ADDENDUM NO. 2

**RECONSTRUCT TOWER APRON
(APPROX. 850 LF X 250 LF)**

**BOIRE FIELD
NASHUA, NEW HAMPSHIRE**

NHDOT NO. SBG 12-03-2009

G1.1A

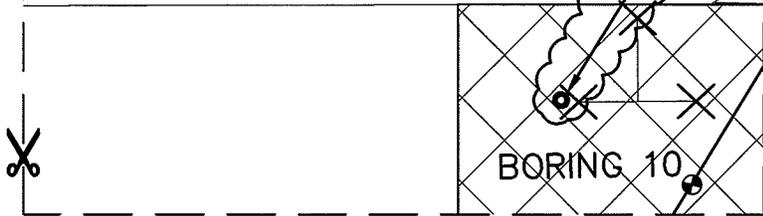
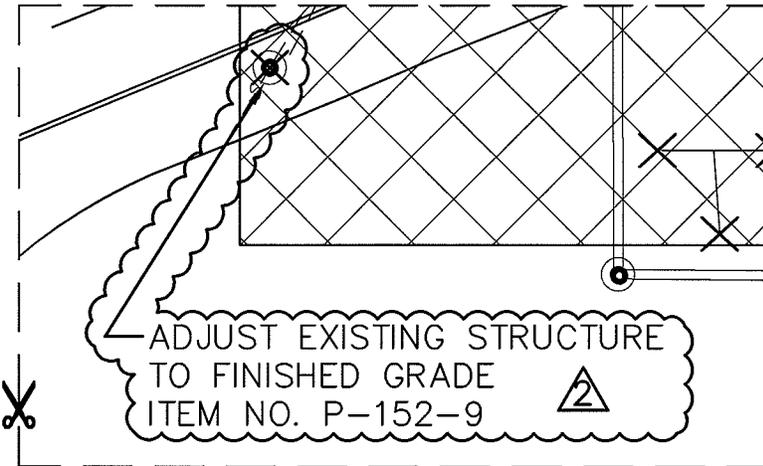
**ADDENDUM NO. 2
REVISIONS TO BE INSERTED
ONTO 'BID SET' DWG. NO. G1.1**

ADJUST EXISTING STRUCTURE
TO FINISHED GRADE
ITEM NO. P-152-9

DATE:	MAY 4, 2009
SCALE:	AS SHOWN
REVISION:	ADDENDUM NO. 2
D1.1A	
2 OF 16

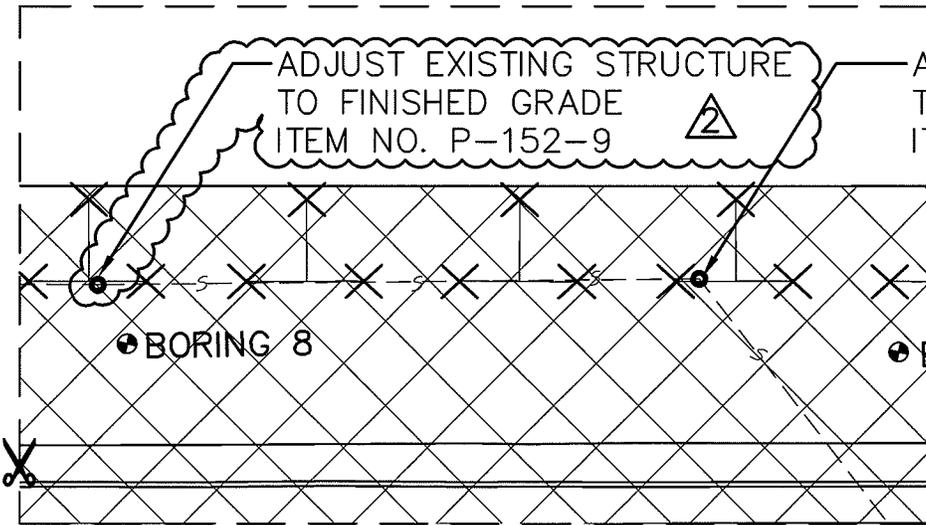
ADDENDUM NO. 2 REVISIONS TO BE INSERTED ONTO 'BID SET' DWG. NO. D1.1			
RECONSTRUCT TOWER APRON (APPROX. 850 LF X 250 LF) BOIRE FIELD - NASHUA MUNICIPAL AIRPORT - NASHUA, NEW HAMPSHIRE SBG NO. 12-03-2009			
PROJ. NO:	DRAWN	REVIEWED	CADD FILE
776440	NAI	BJH	776440-D11-ADD2

DATE:	MAY 4, 2009
SCALE:	AS SHOWN
REVISION:	ADDENDUM NO. 2
C1.1B	
3 OF 16

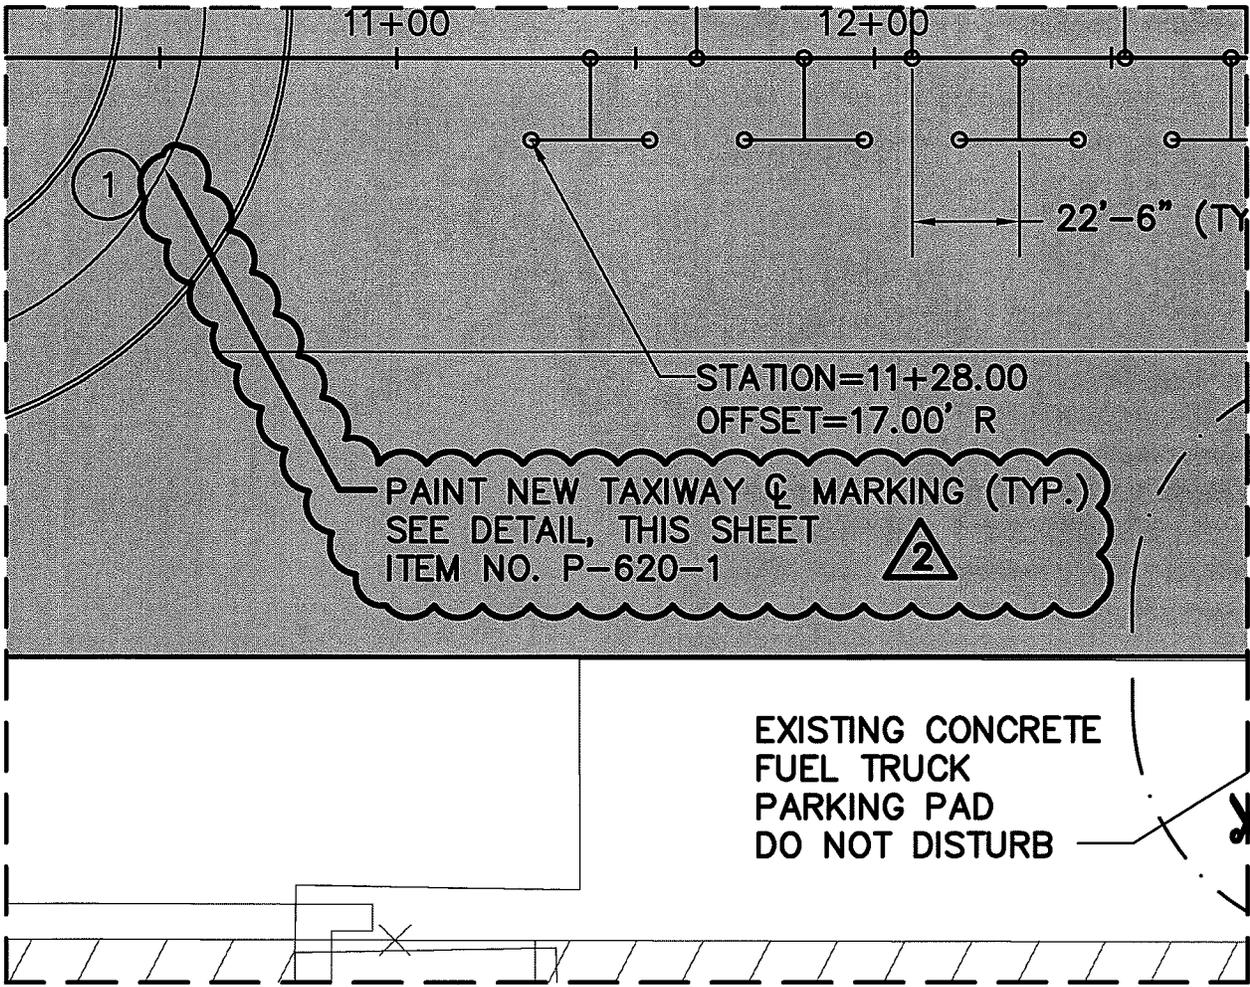
ADDENDUM NO. 2			
REVISIONS TO BE INSERTED ONTO 'BID SET' DWG. NO. C1.1			
RECONSTRUCT TOWER APRON (APPROX. 850 LF X 250 LF) BOIRE FIELD - NASHUA MUNICIPAL AIRPORT - NASHUA, NEW HAMPSHIRE SBG NO. 12-03-2009			
PROJ. NO:	DRAWN	REVIEWED	CADD FILE
776440	NAI	BJH	776440-C11-ADD2

DATE:	MAY 4, 2009
SCALE:	AS SHOWN
REVISION:	ADDENDUM NO. 2

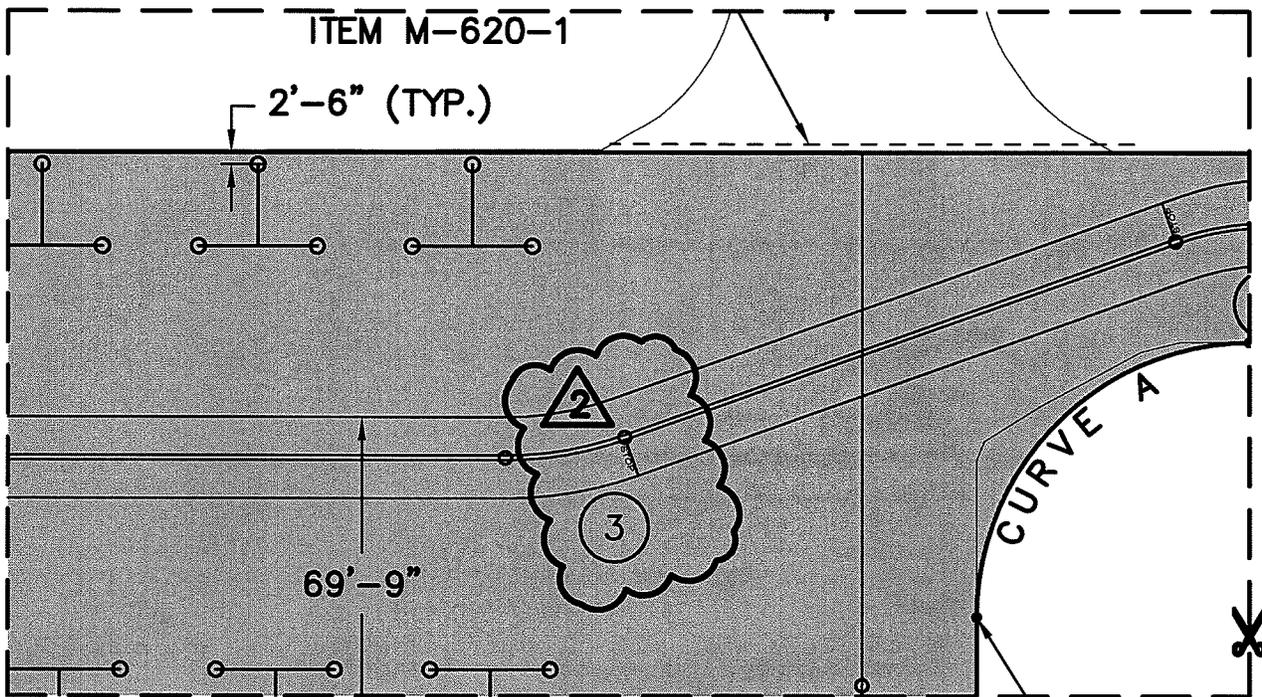
ADDENDUM NO. 2
 REVISIONS TO BE INSERTED
 ONTO 'BID SET' DWG. NO. C1.1

DATE:	MAY 4, 2009
SCALE:	AS SHOWN
REVISION:	ADDENDUM NO. 2
C3.2C	
5 OF 16

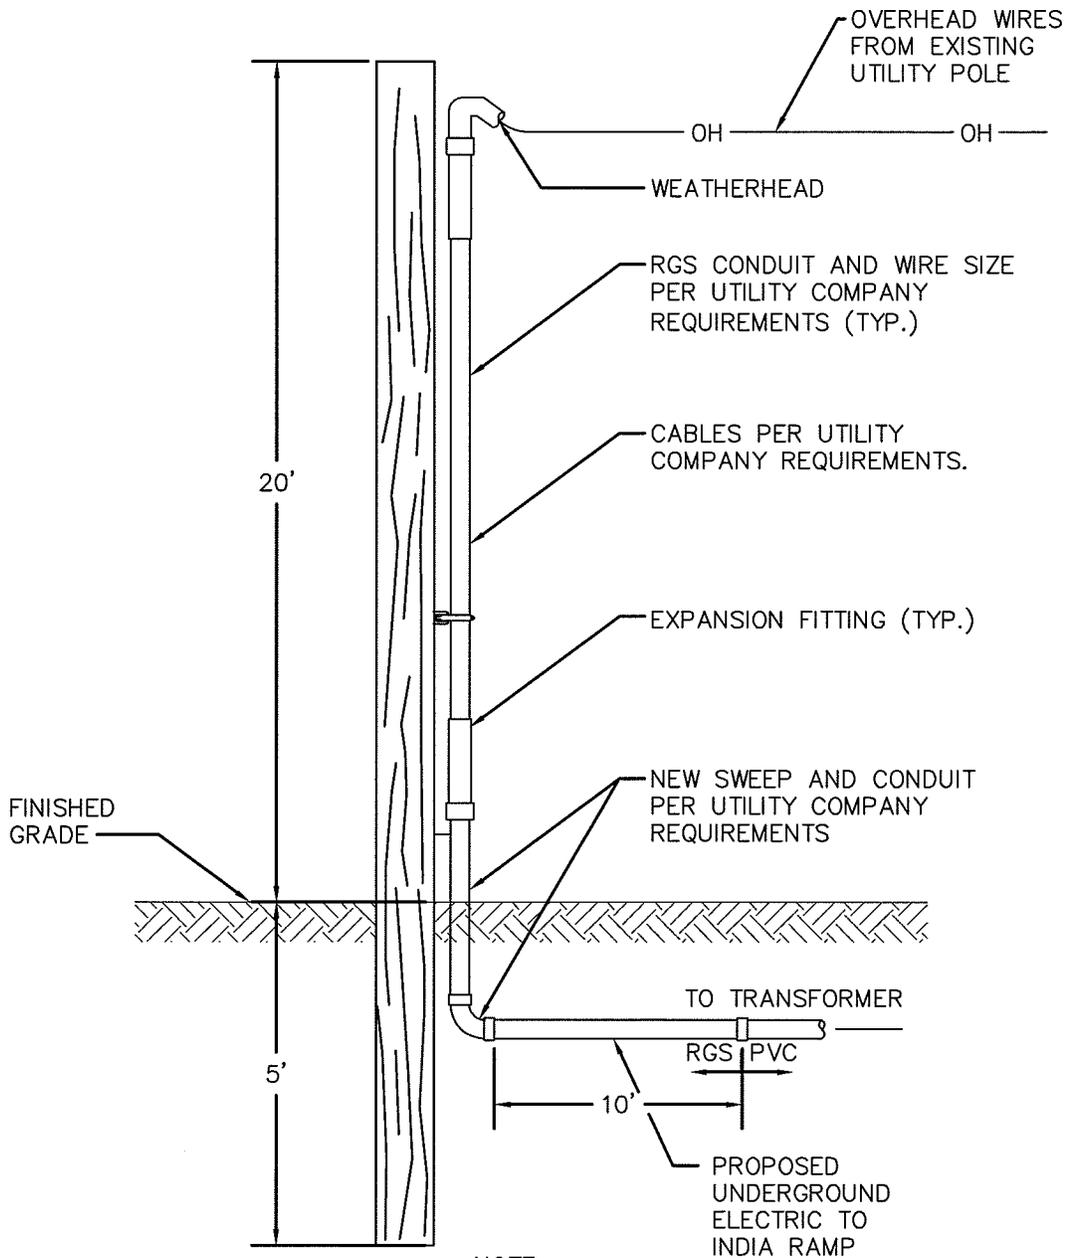
ADDENDUM NO. 2 REVISIONS TO BE INSERTED ONTO 'BID SET' DWG. NO. C3.2			
RECONSTRUCT TOWER APRON (APPROX. 850 LF X 250 LF) BOIRE FIELD - NASHUA MUNICIPAL AIRPORT - NASHUA, NEW HAMPSHIRE SBG NO. 12-03-2009			
PROJ. NO:	DRAWN	REVIEWED	CADD FILE
776440	NAI	BJH	776440-C32-ADD2

L1.3C

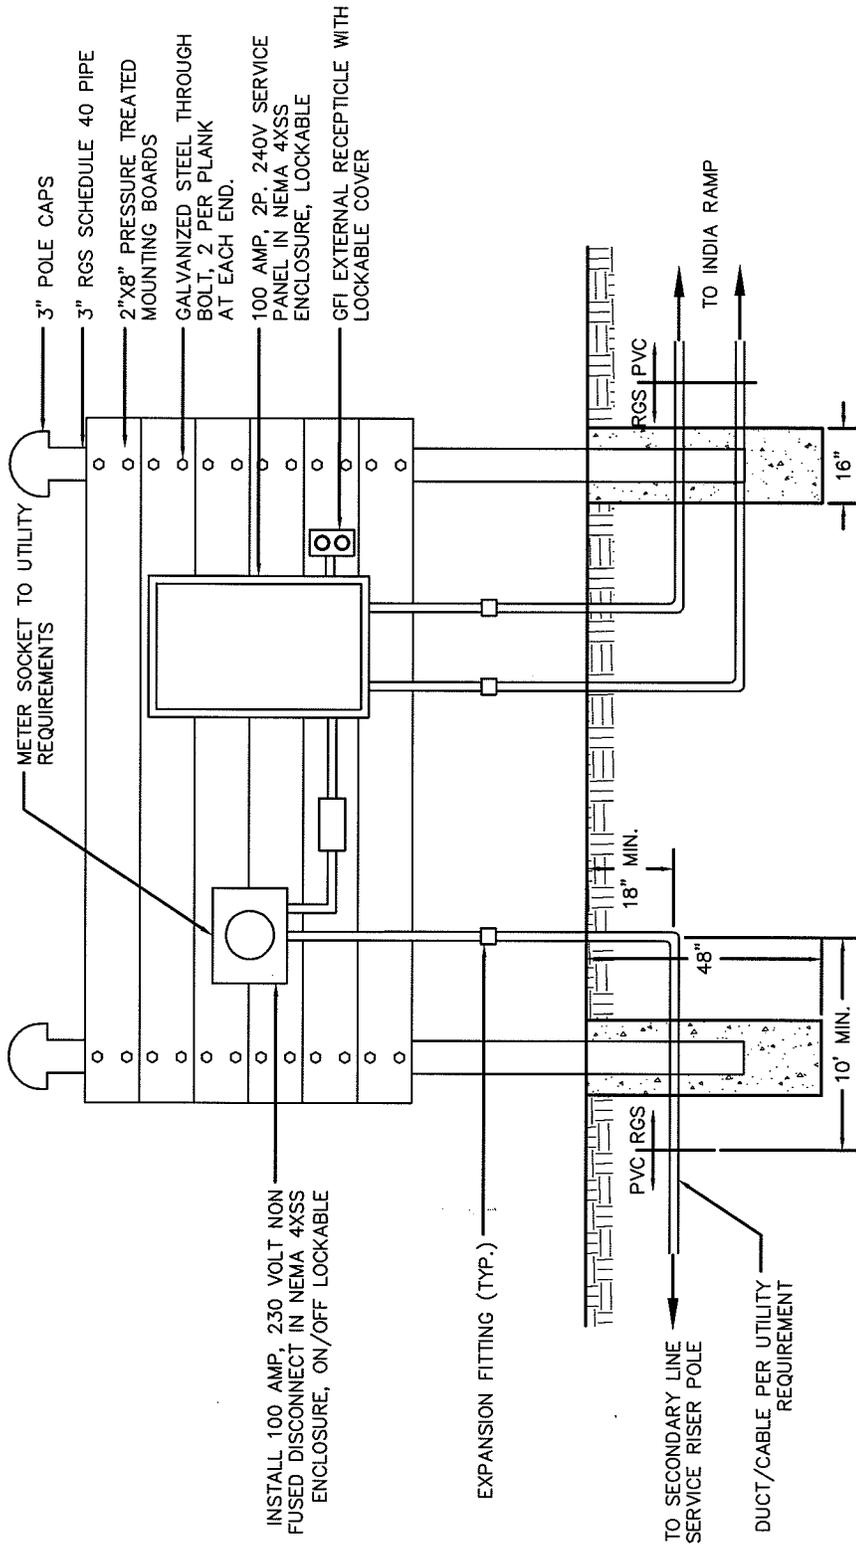
ALL CONDUITS AND FITTINGS TO BE SIZED PER UTILITY COMPANY REQUIREMENTS

SECONDARY LINE SERVICE RISER POLE DETAIL

DATE:	MAY 4, 2009
SCALE:	AS SHOWN
REVISION:	ADDENDUM NO. 2
L1.3D	
8 OF 16

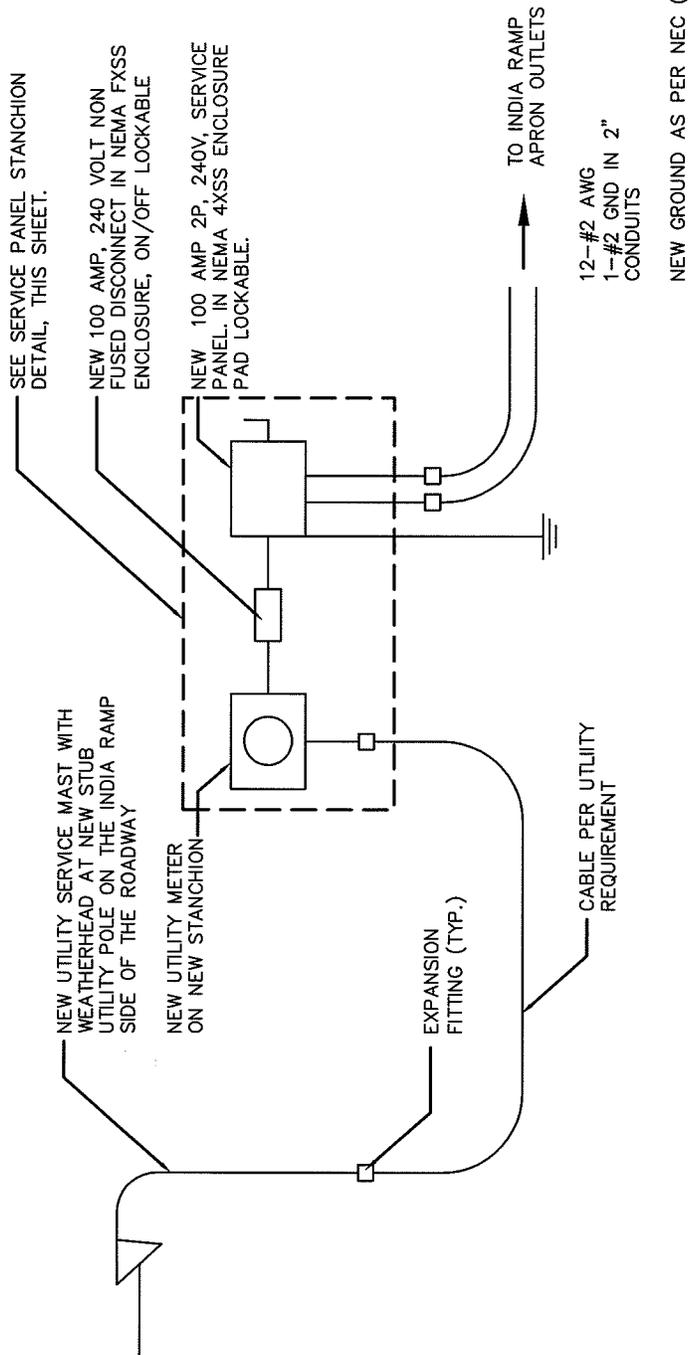
SERVICE PANEL STANCHION DETAIL

L1.3E

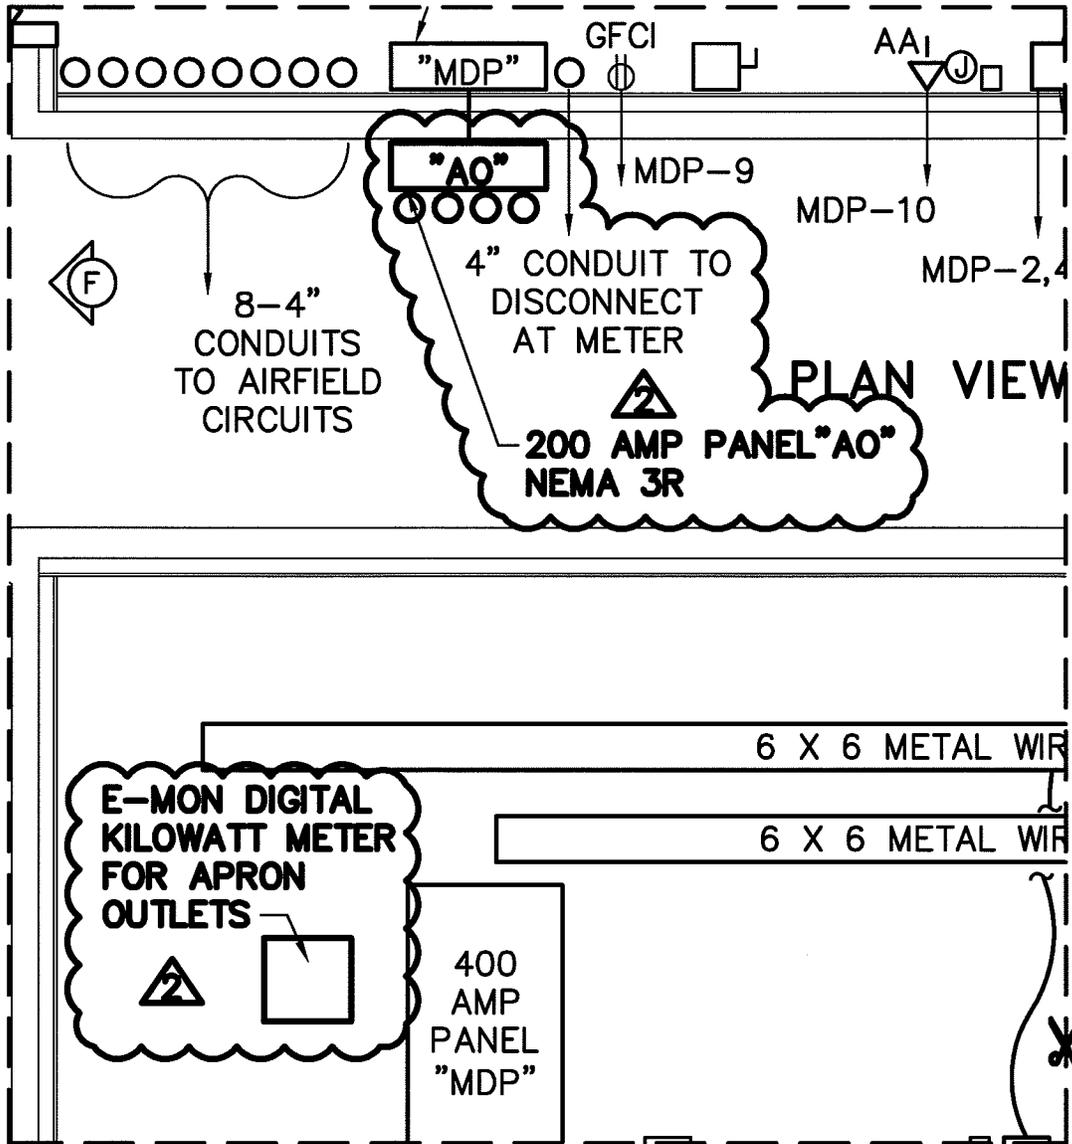
**INDIA RAMP POWER ONE LINE
DIAGRAM**
N.T.S.

L3.1B

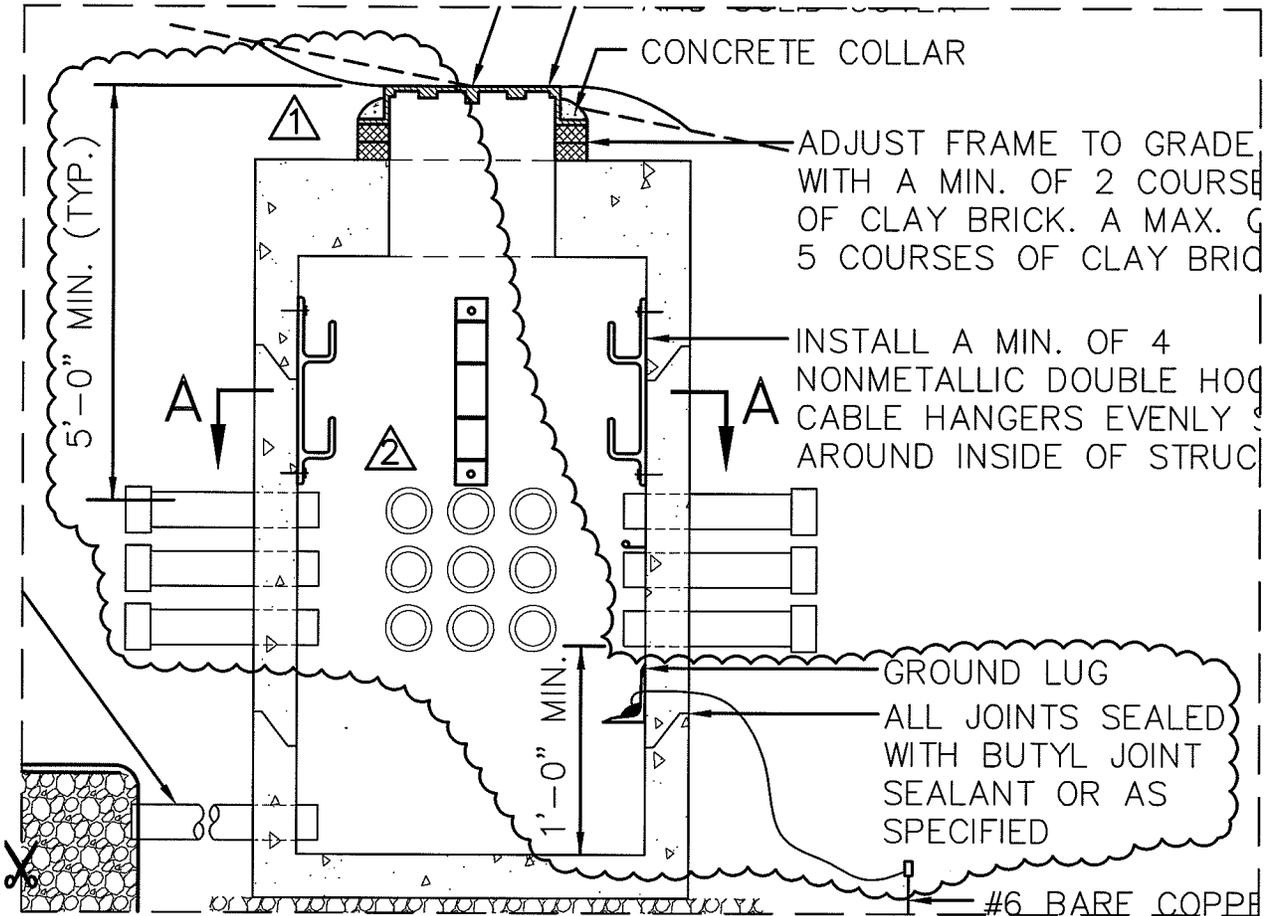
REVISIONS TO BE INSERTED
 ONTO 'BID SET' DWG. NO. L3.1

L2.1A

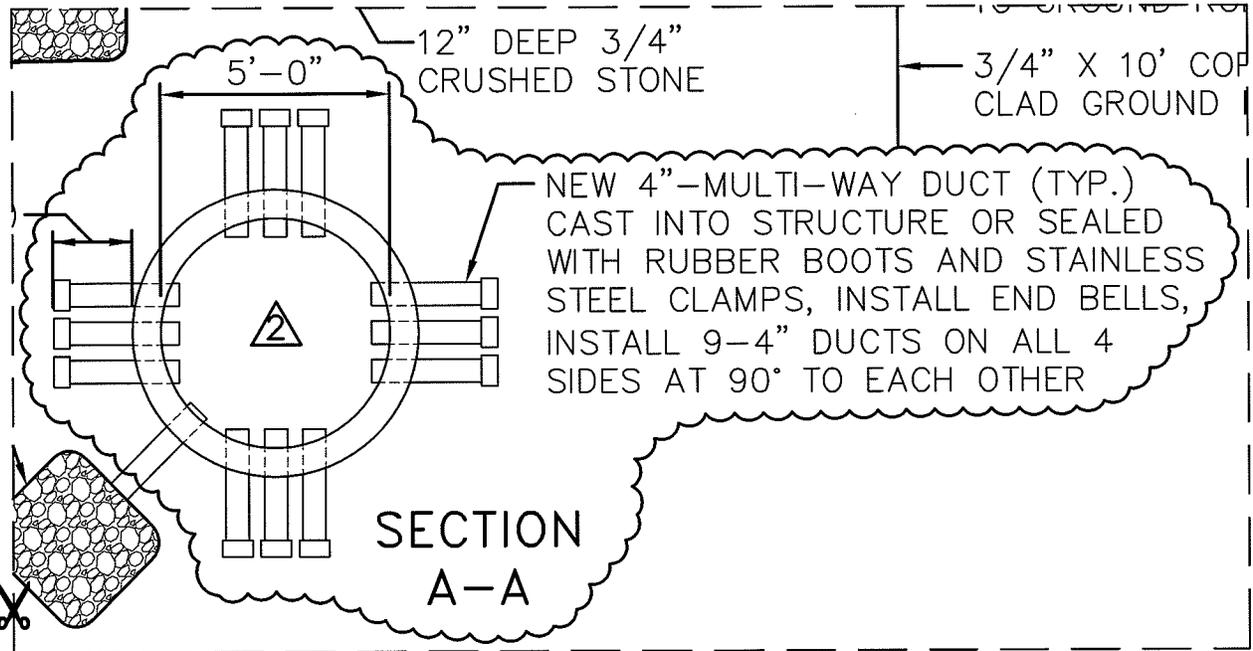
ADDENDUM NO. 2
 REVISIONS TO BE INSERTED
 ONTO 'BID SET' DWG. NO. L2.1
